**Sub: Diversion of 211.8427 hectare of forest land for the construction of Dugar 500 MW Hydro Electric Project in favour of NHPC, within jurisdiction of Pangri Forest Division, District Chamba.**

**Memo,**

Kindly refer to GoI, MOEF and CC letter No. 8-15/2022-FC dated 05.09.2023 on the subject cited above.

**Subject: -** Diversion of 211.8427 hectare of forest land for the construction of Dugar 500 MW Hydro Electric Project in favour of NHPC, within the jurisdiction of Pangi Forest Division, District Chamba (HP).

Figure 10.10: Layout of Muck Disposal area

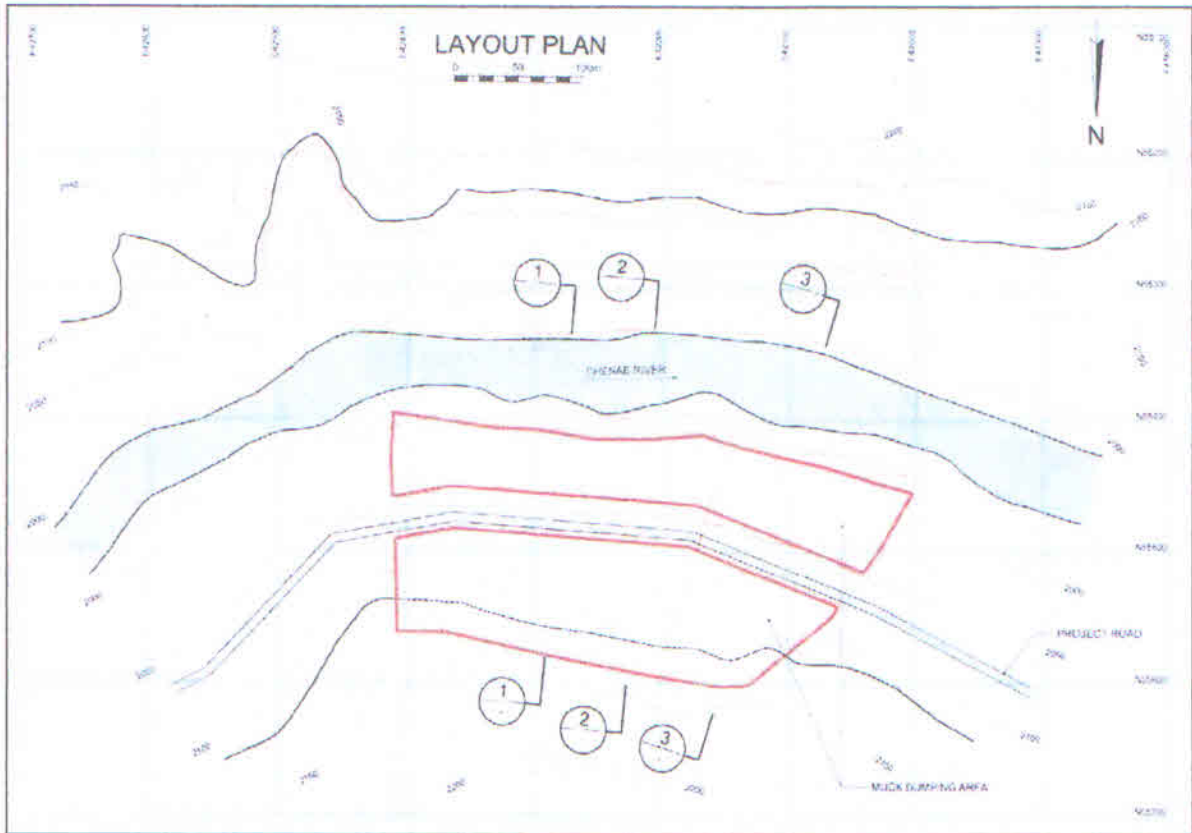
vii. The Muck dumping (8.5797 ha) and the job facility area (7 ha) can be taken on non-forest land. The justification for proposing the same on Forest land may be submitted.

Reply: Muck dumping site involves 8.5797 ha forest land and job facility area involve 7.08 ha forest land as per requirement of the Project. The total land required for the construction of project is 220.62 ha. Out of which 211.84 ha is Forest land and the remaining 8.78 ha is Non-Forest land. As per requirement, a single patch of 8.5797 ha forest land has been identified and found suitable for temporarily disposal of muck, and 7.08 ha forest land has been identified and found suitable for temporarily job facility area (like batching plant, pre-fabrication yard etc). Both the temporarily muck dumping site and job facility area will be handed over back to the State Forest Department after completion of construction activities. After the completion of dumping activity, proper restoration plan with Biological and Engineering measures will be implemented for restoration of the dumping area. A suitable restoration plan has been proposed under the EMP for muck dumping site (copy enclosed from page No. 248 to 255). After the completion of work from job facility area, proper restoration plan with Biological and Engineering measures will be implemented for restoration of the job facility area. A suitable restoration plan has also been proposed under the landscaping and restoration plan of EMP Plan.

Keeping the above requirement, one muck disposal site has been identified downstream of the proposed powerhouse with a total area of 8.58 ha and capacity has been worked as 8,75,000 cum which is much more than the total quantity of muck to be disposed of (refer to **Figure 10.10**).

# Drainage Map of Chenab River in Downstream of Dugar HEP

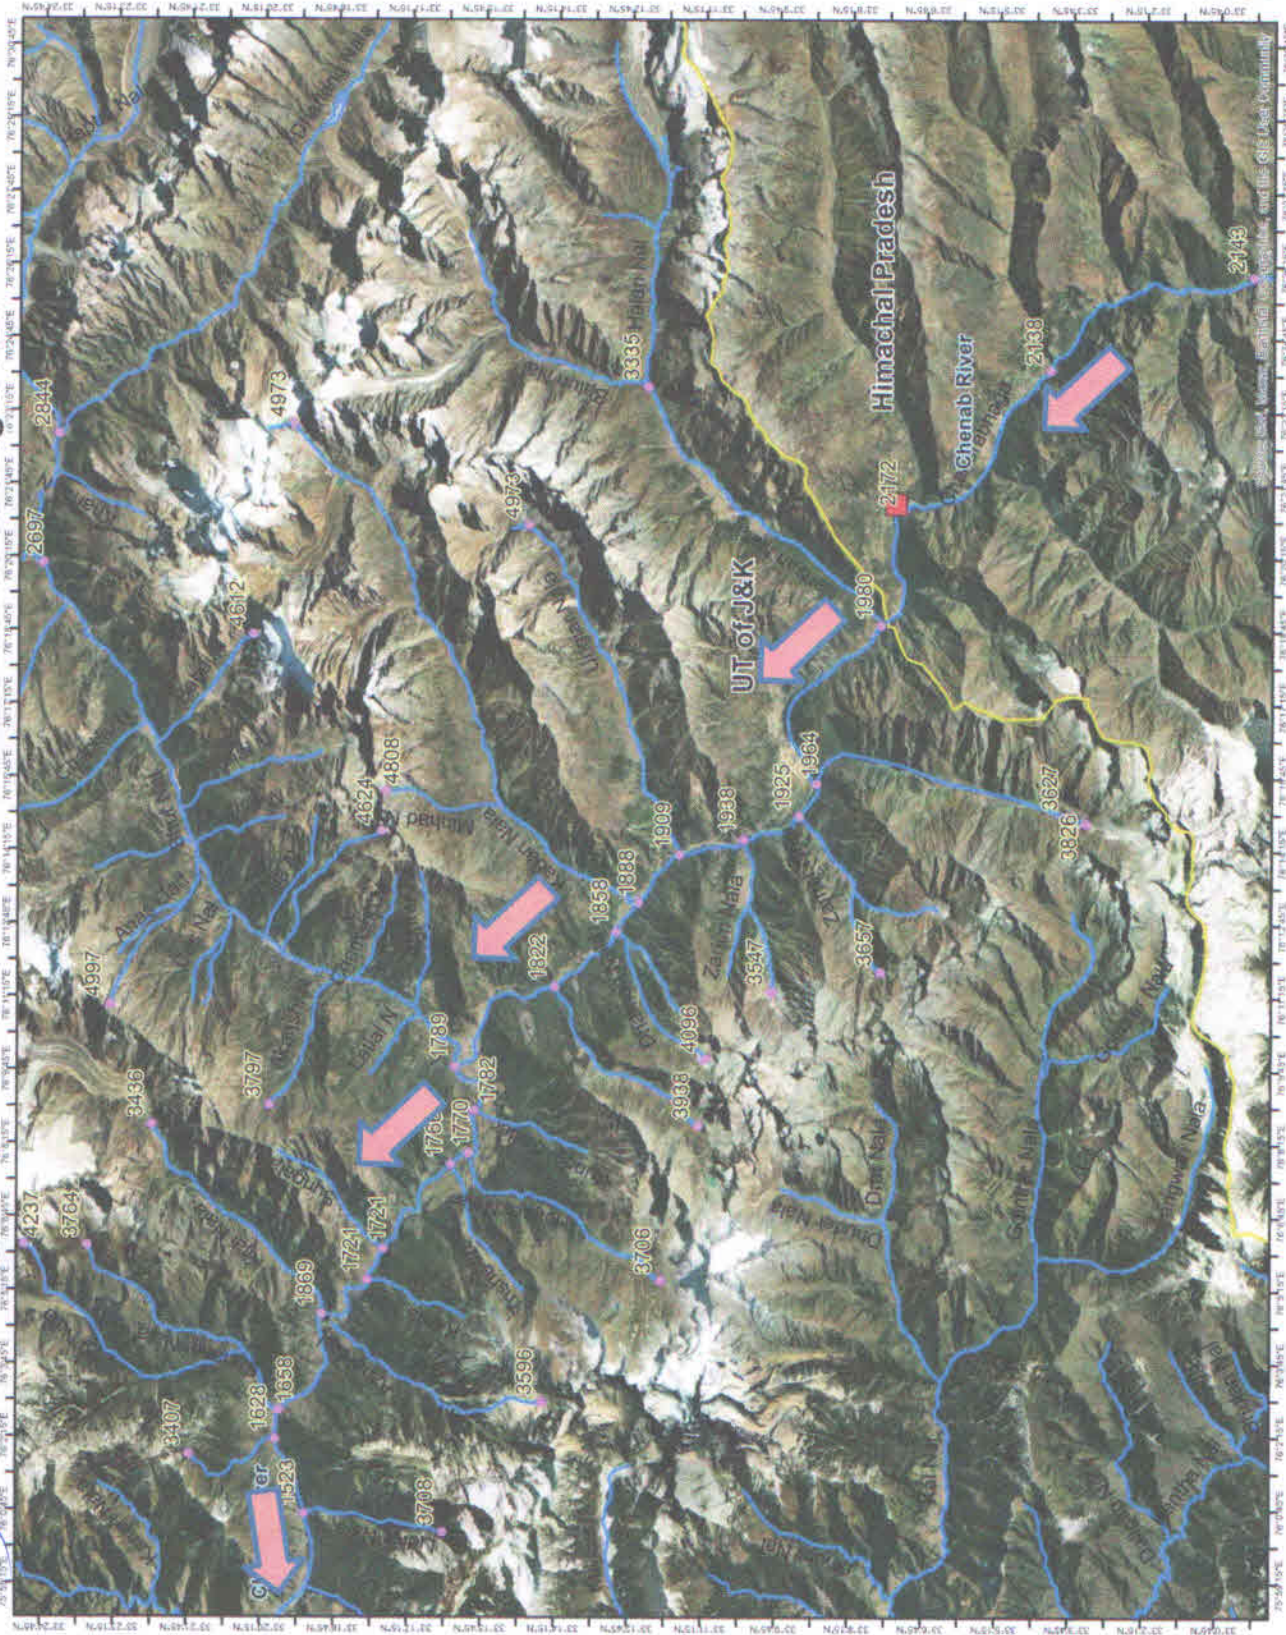
8	The State Govt. shall submit a detailed report regarding the impact of the project on the water flow in the areas downstream. The impact of the project on farming and flow of water in the distributaries downstream shall also be studied and a report shall be submitted	The Cumulative Environmental Impact Assessment (CEIA) study carried out in year 2016 for Chenab River basin in Himachal Pradesh under the agencies of MoEF&CC, GoI has recommended the quantum of environmental flow for Dugar HEP. The detailed reply given by User Agency is uploaded against additional information in Online Part-I and reply of DFO Pangri is attached herewith.

Regarding distributaries, it is intimated that river flows in gorge area in downstream area of Dugar HEP and there are several tributaries contributing enhanced flow of water in the downstream area. However, no distributaries are formed by river. As such, no impact on distributaries is anticipated. Drainage Map of Chenab River in downstream area of Dugar HEP is attached (**Annexure-IV**).
